SOUTHERN CALIFORNIA EDISON'S FALCON RIDGE SUBSTATION PROJECT

CPUC A.10-12-017
SCH NO. 2011041009

Final Environmental Impact Report

Prepared for
California Public Utilities Commission

Final EIR Figure 2-3a

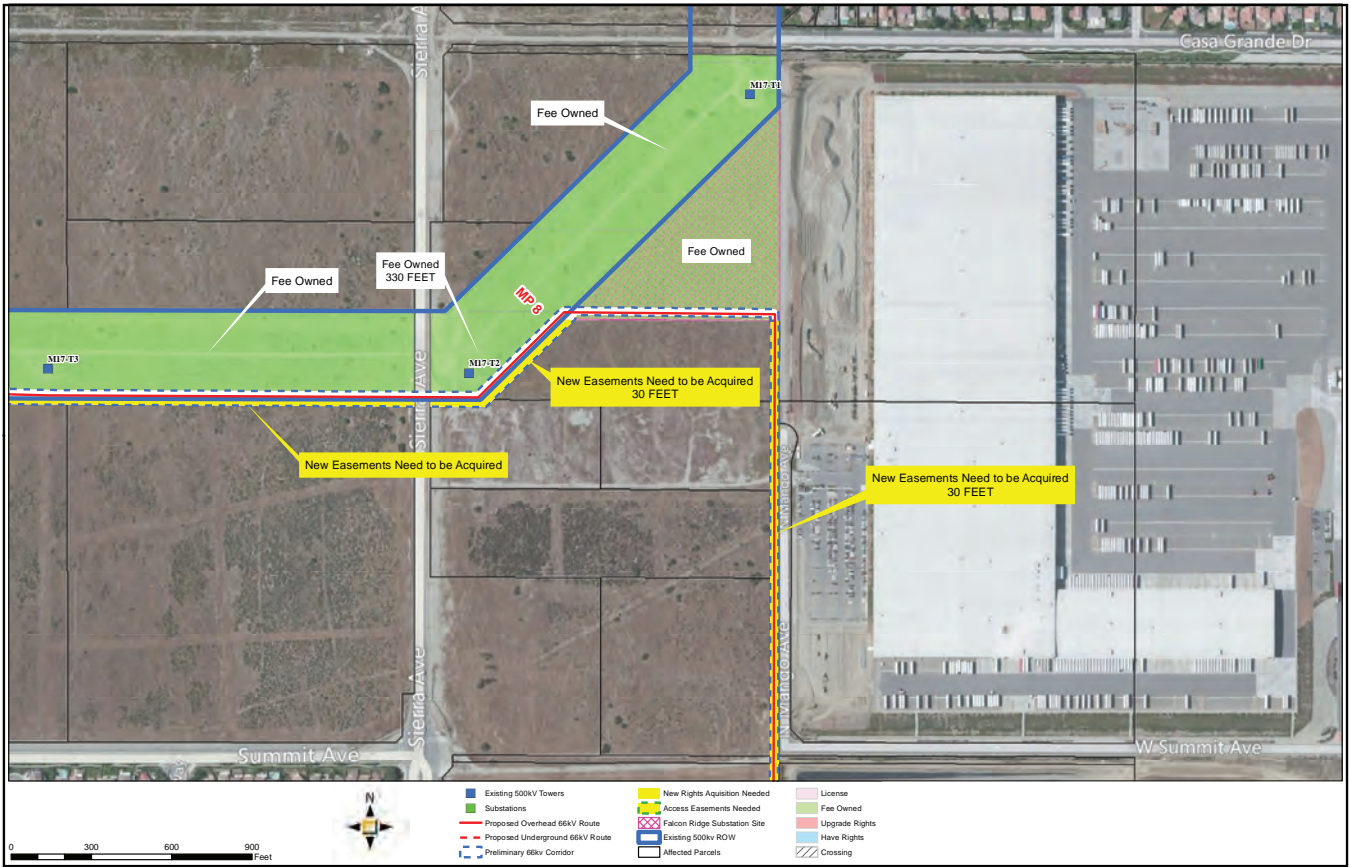
A-1.45 Section 2.7, “Rights-of-Way Requirements” on Draft EIR page 2-16 is revised as follows:

This clarification of new right-of-way requirements is shown on Figures 2-3a through 2-3c. In general, the Project would cause or contribute to each of the direct, indirect, and cumulative effects analyzed in the EIR regardless of the underlying ownership or control of the affected property. Specific concerns about potential effects of this ROW clarification on Land Use and Planning are addressed in responses to Comment Letter C-3.

Figure 2-3
Substation Layout

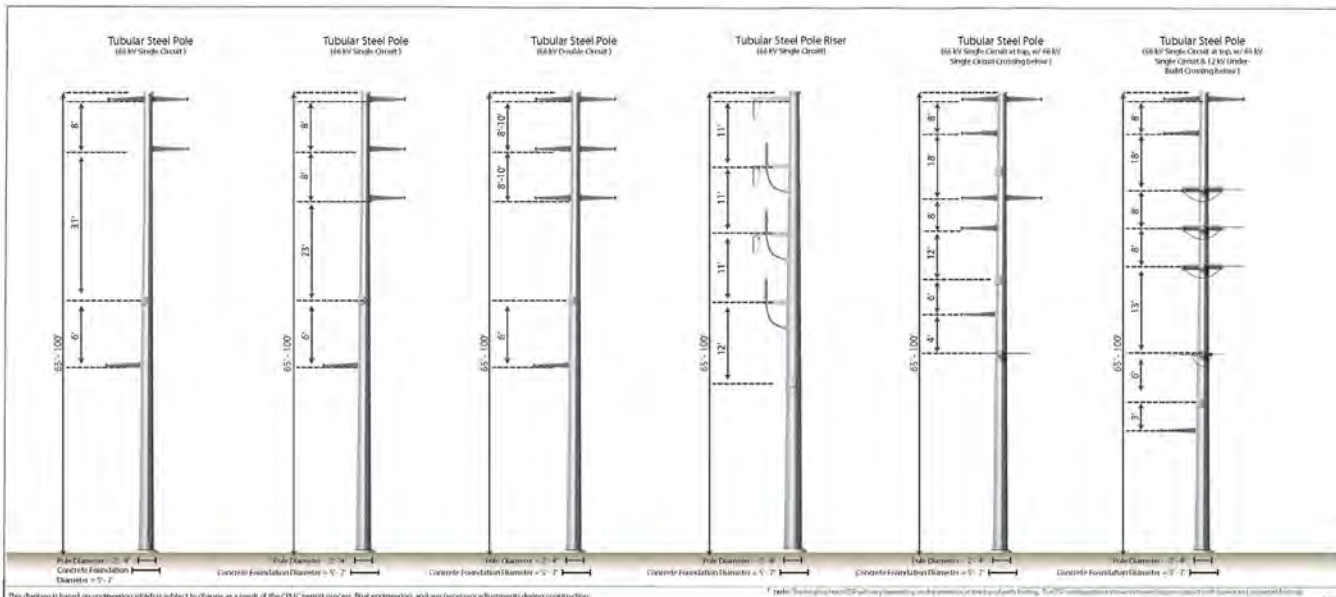
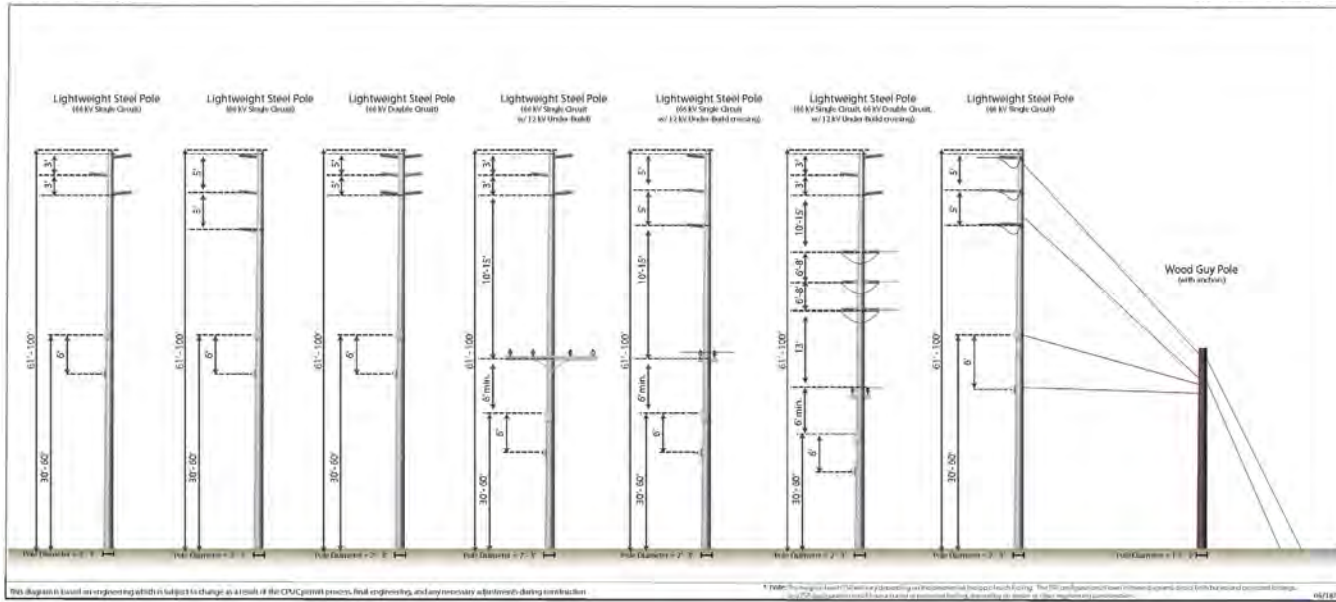
Section	Page	Comment	Suggested Revision
Project Description	2-6	Please replace existing Figure 2-3 with the revised Figure 2-3 provided by SCE. In particular, please note the following changes: <ul style="list-style-type: none"> • The 2 TSPs and associated subtransmission lines would be moved outside of the substation wall (as shown in close up detail to the figure in the right). • The restroom has been relocated from the east side of the substation to the west side of the substation. • 66kV capacitors have been deleted from view as they are not part of the Falcon Ridge Substation Project. 	Please utilize the attached revised Figure 2-3.
Project Description	2-7	Under the heading Substation Equipment and Associated Facilities (66 kV Switchrack) , please revise the text to note the updated anticipated dimensions of the operating and transfer bus.	Each operating and transfer bus would be 144 <u>196</u> feet long and consist of two 1,590 kcmil (thousand circular mills) Aluminum Conductor Steel Reinforced (ACSR) for each of the three electrical phases.

A-1.32 Figure 2-3 on page 2-6 of the Draft EIR has been replaced in order to show the modified substation layout (see Appendix G).
